City of Kingston
Report to Kingston Heritage Properties Committee
Report Number HP-24-043

Subject: Applications for Ontario Heritage Act Approval

Address: 411 Wellington Street (P18-520)

File Numbers: P18-095-2024, P18-096-2024, P18-097-2024, P18-098-2024, P18-099-2024 and P18-101-2024

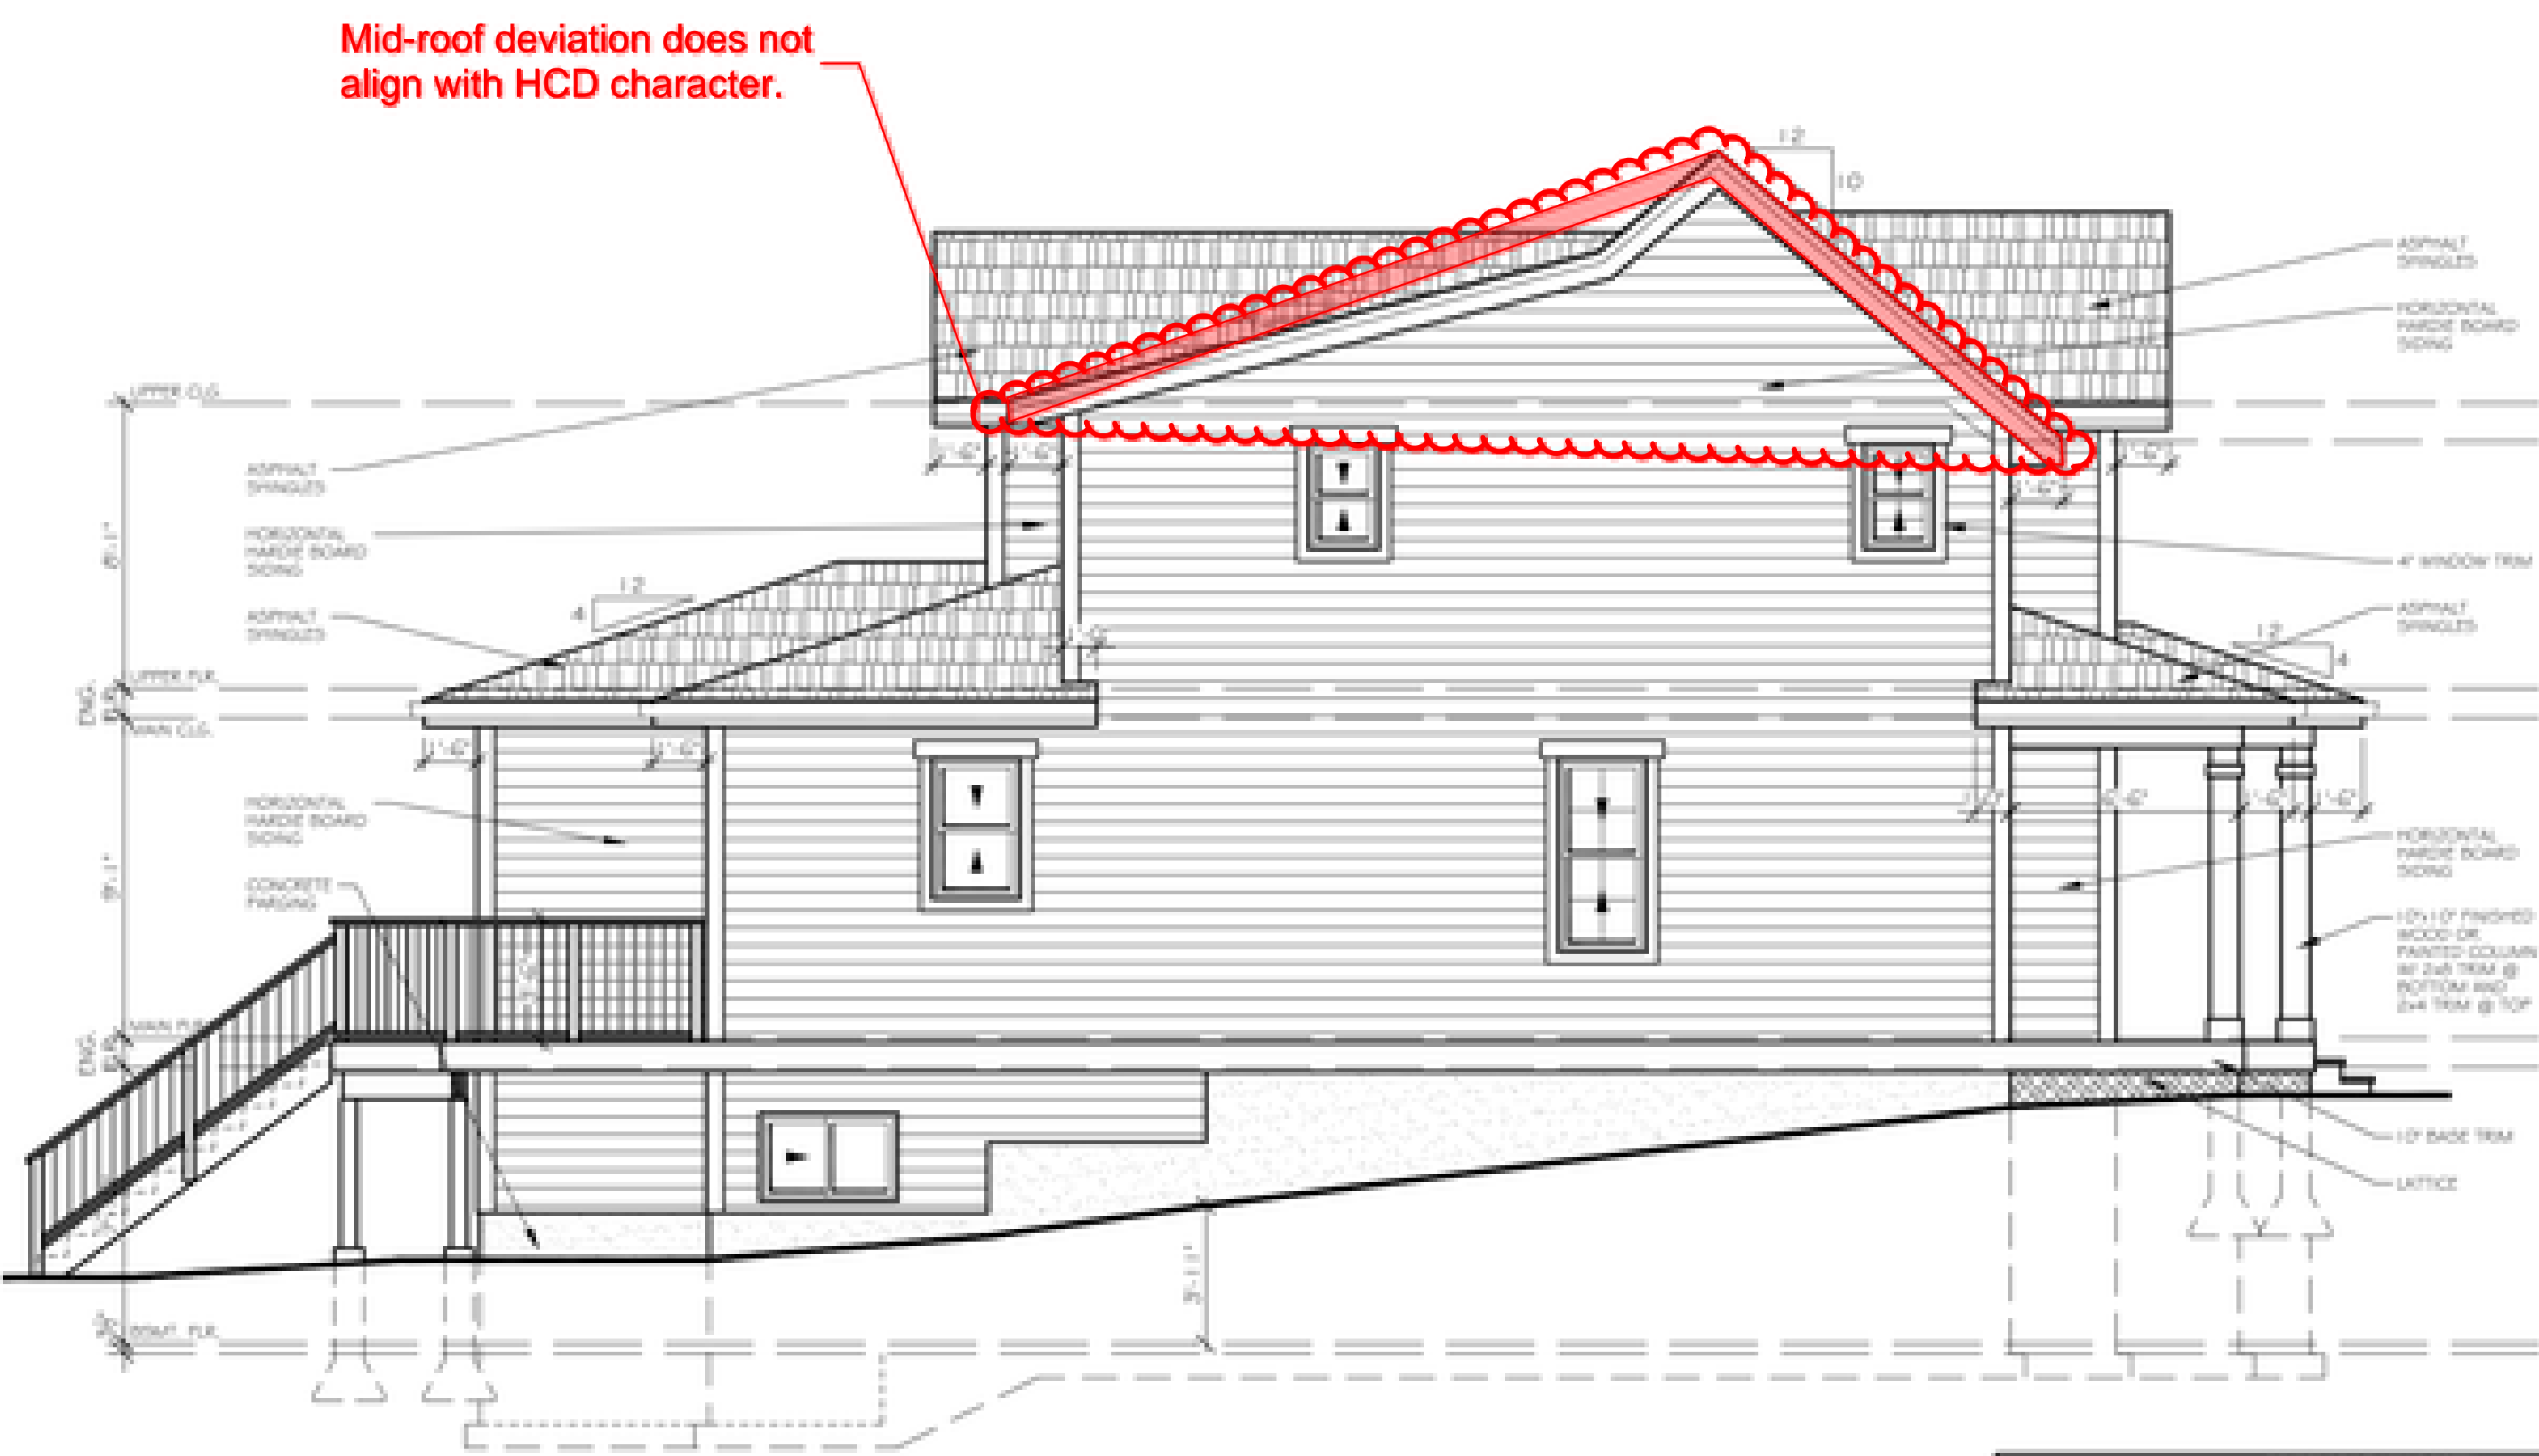
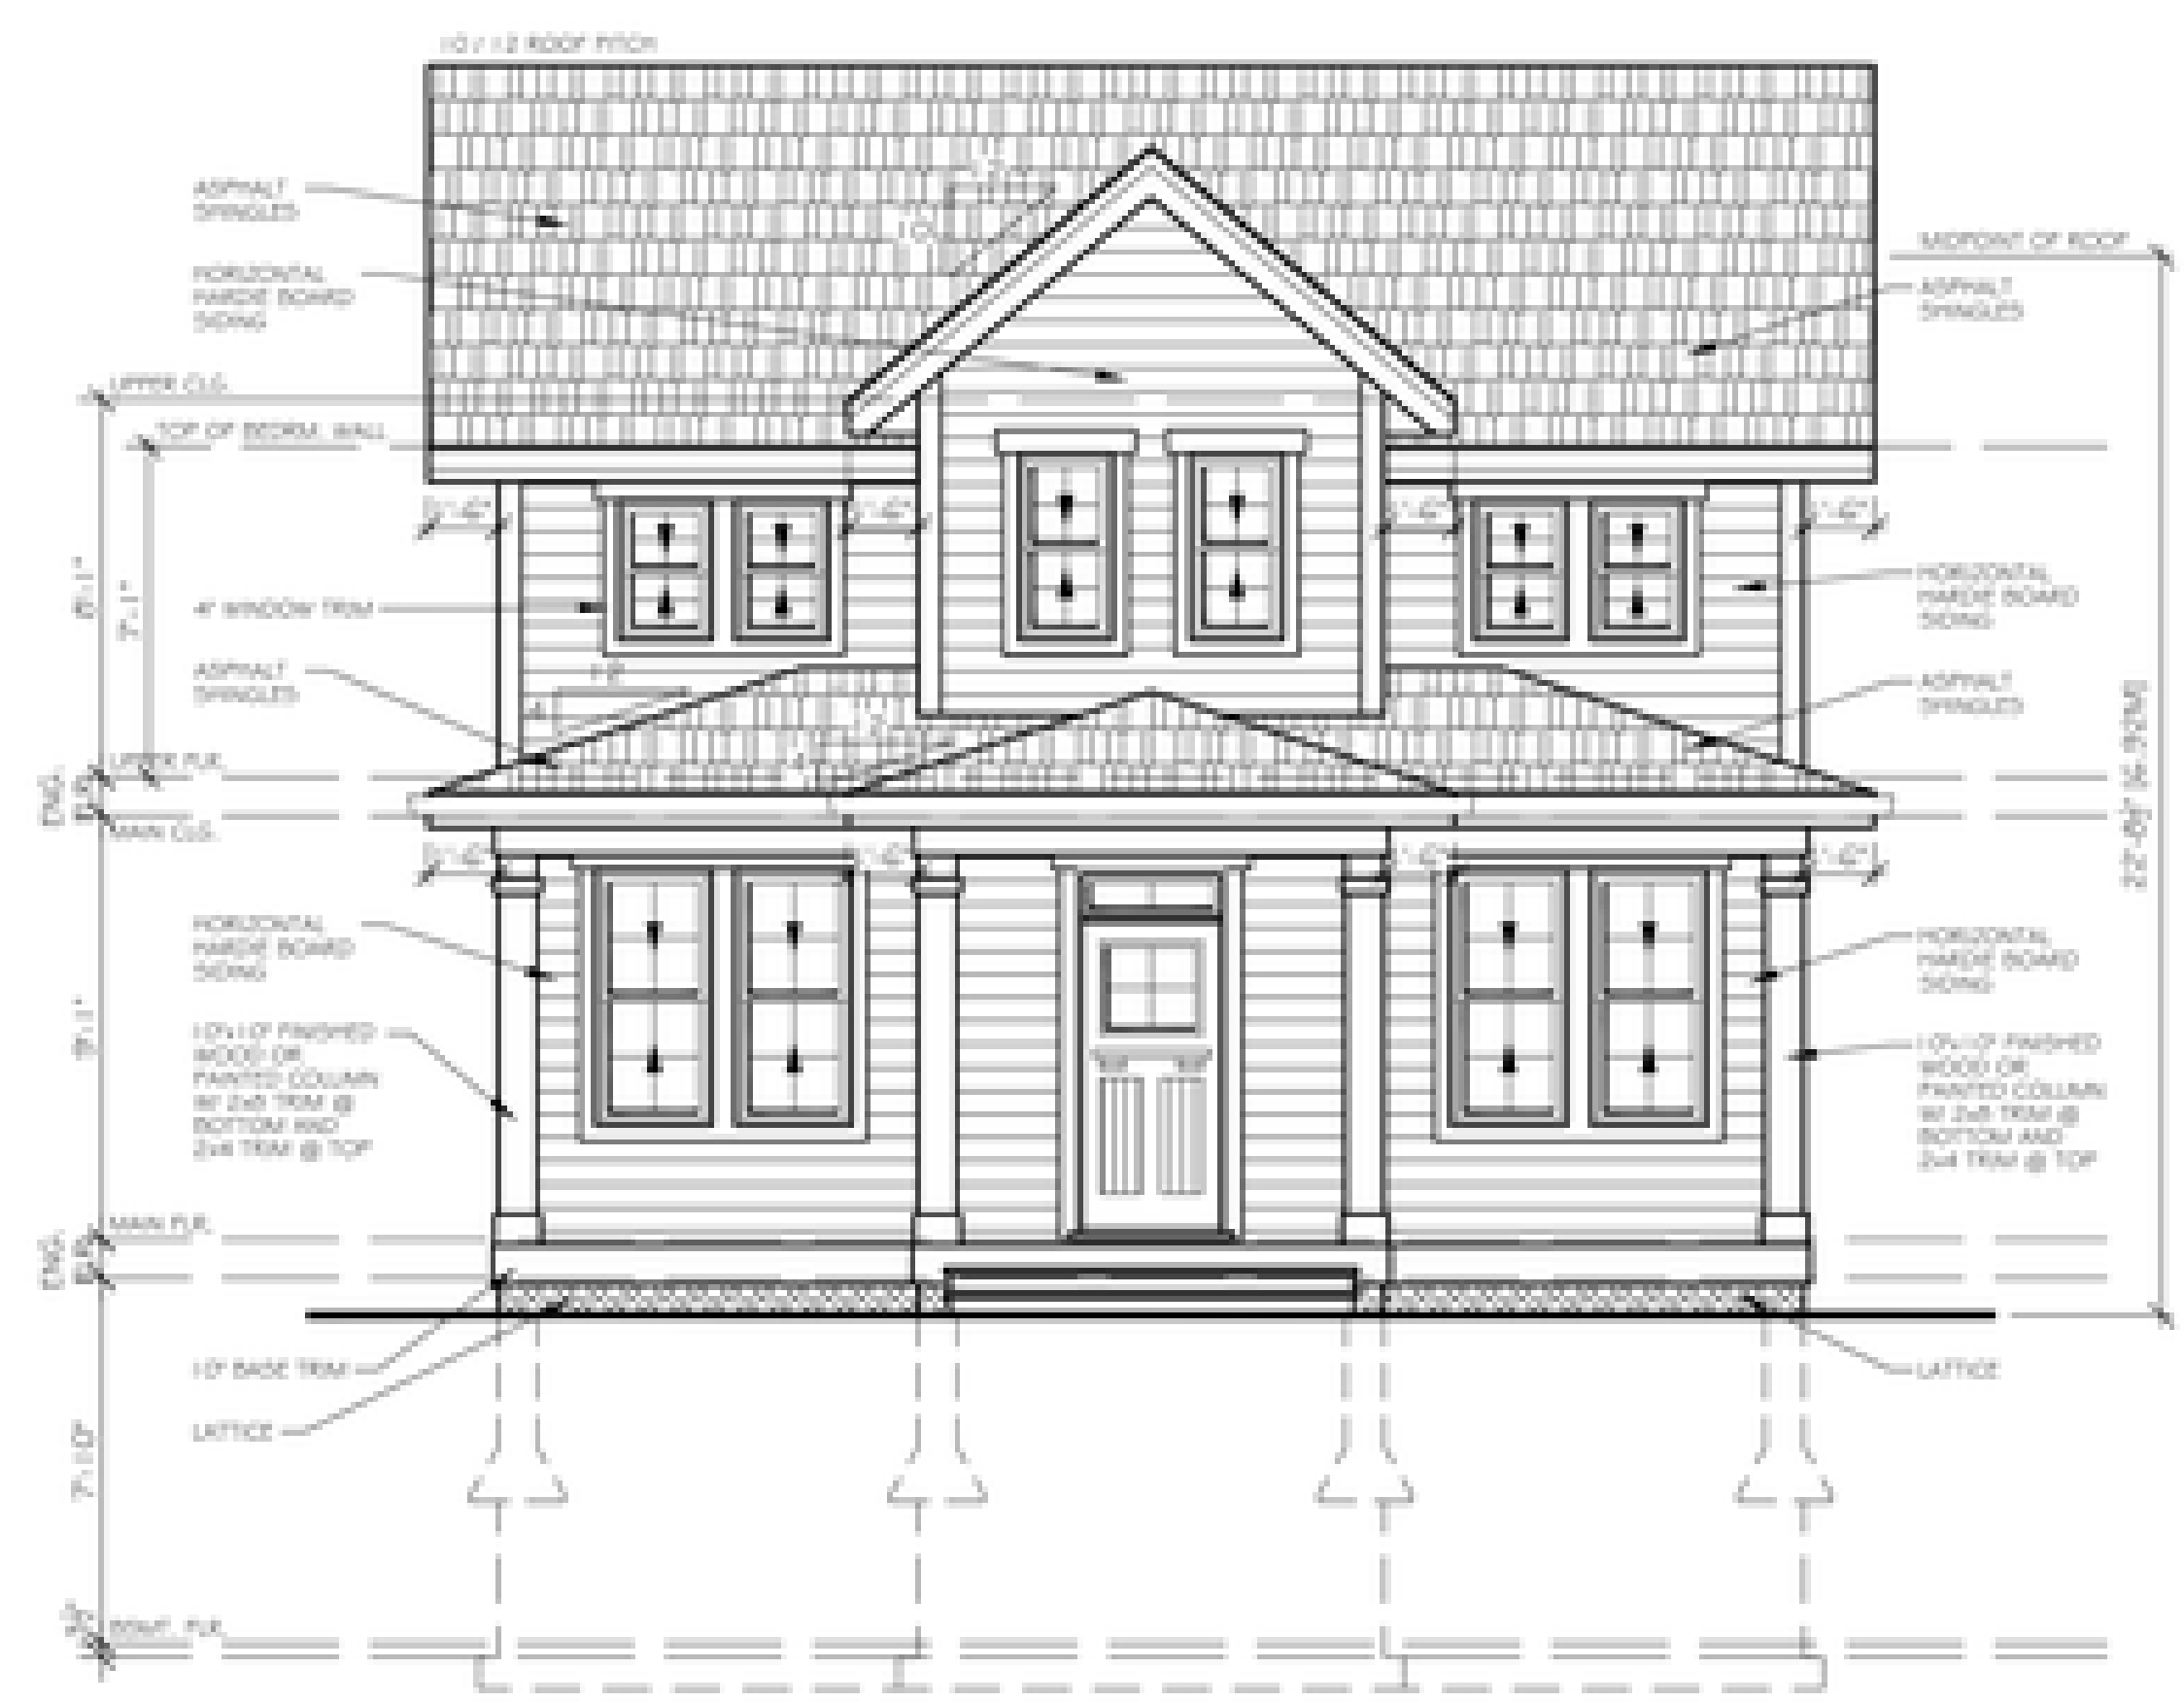
The subject Lot is located on the western side of Old Kiln Crescent and central within the subdivision. The proposed design of the new dwelling conforms to the policies of the District Plan and is supportable. During the review of this application, staff noted the addition of a projecting gable on the front porch roof. While not a requirement and not an egregious deviation from the goals and objectives of the District Plan, the addition of the decorative roof feature on the primary front porch does not align with the heritage character of the HCD, which emphasizes simple roofs. Staff have included a condition of approval to require the owner to consider amending the front porch plan to remove the extra roof feature.

1. The applicant shall consider amending the design of the front porch to remove the central gable on the porch roof;
2. The applicant shall consider reducing the amount of glazing on the street facing elevation of the property, and that the use of vertically oriented single sash windows on the front elevation is encouraged and permitted as an option to the double windows proposed;
